CHILDREN'S HOSPITAL
OF ORANGE COUNTY

TOWER II

LEVEL 2
MECHANICAL PLAN
AREA - P ENLARGED

M3.2P.1

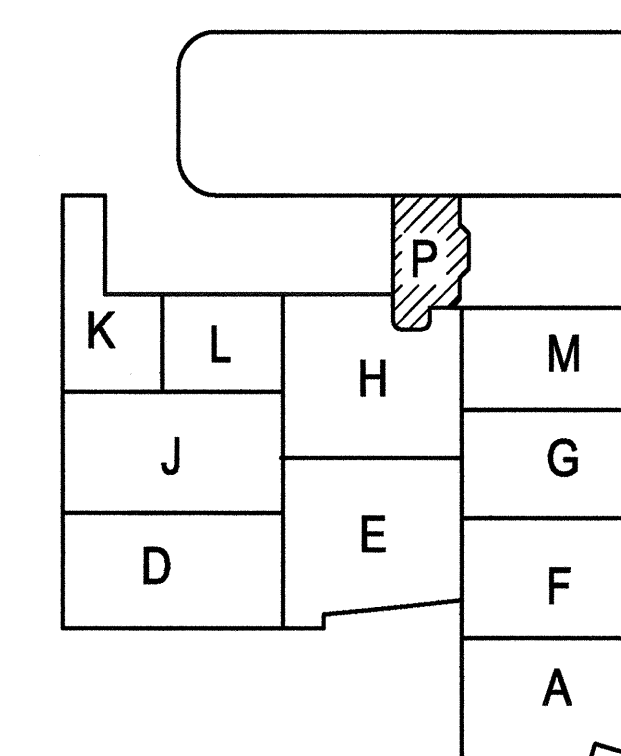
RFI #5552
T-stats on demo'd
walls are to be deleted
